COMAL COUNTY

Permit of Authorization to Construct an On-Site Sewage Facility Permit Valid For One Year From Date Issued

Permit Number: 114561
Issued This Date: 11/14/2024
This permit is hereby given to: Allen & Mary Webb

Engineer's Report
for the modifications to the
Subsurface Sanitary Sewage Disposal
System
For the
Webb Property

3 500-GALLON AEROBIC TREATMENT UNIT AND PUMP TANK DETAIL
NOT TO SCALE

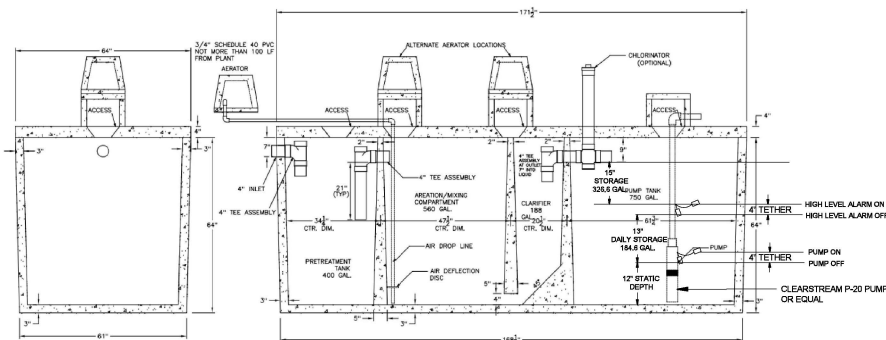
- 1 ✓ The owner name(s) on the permit application must match the owner name(s) as described on the recorded warranty deed. Add Mary Webb to the permit application.
- ✓. The maintenance provider must sign the 2 year initial service policy.
- ✓. Provide a clean-out between the structure and the ATU.
- ✓. Provide drip field installation details (the depth of the drip tubing, the amount and type of backfill, vegetation plan over drip field).
- 5. Revise as needed and resubmit.

1. See revised permit application enclosed with this submittal. All owners of the subject property have signed the revised application.
2. See maintenance contract enclosed with this submittal. Both the owners and the maintenance provider have signed.
3. A cleanout is now shown on the site plan between the sewer stub and the aerobic unit.
4. Drip installation details (Plan and section views) are now shown on the engineering plan set.
5. See revised engineering report enclosed with this submittal.

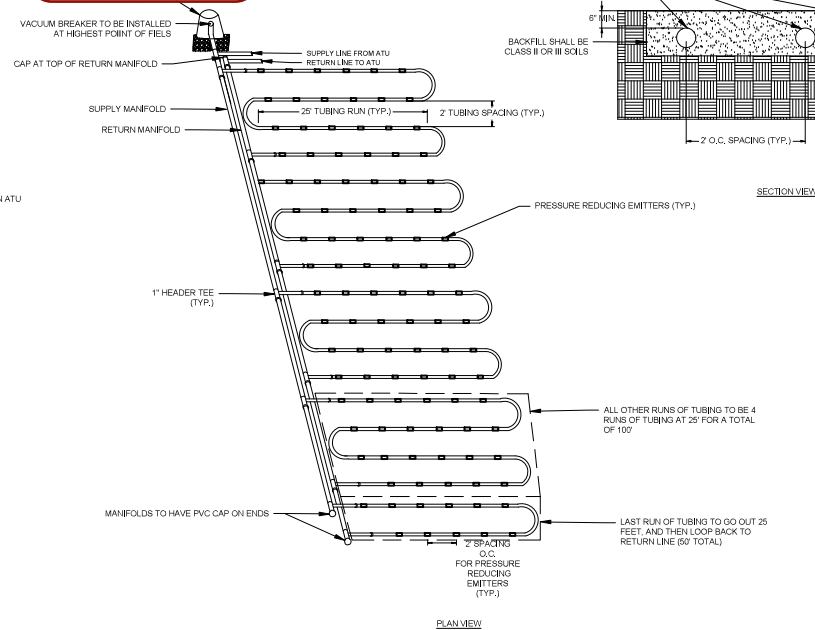
The following information is needed before I can continue processing the referenced permit submittal:

1.  preliminary inspection was completed on 7/02/2024 and observed one test hole at 12 inches, and scattered surface rock. With a loading rate of 0.20 a minimum of 12 inches of soil is required below the drip tubing. Planning materials indicate the tubing will be trenched in 6 inches. Trenching in 6 inches will not allow for the required 12 inches of soil below the drip tubing.
2. Revise as needed and resubmit.
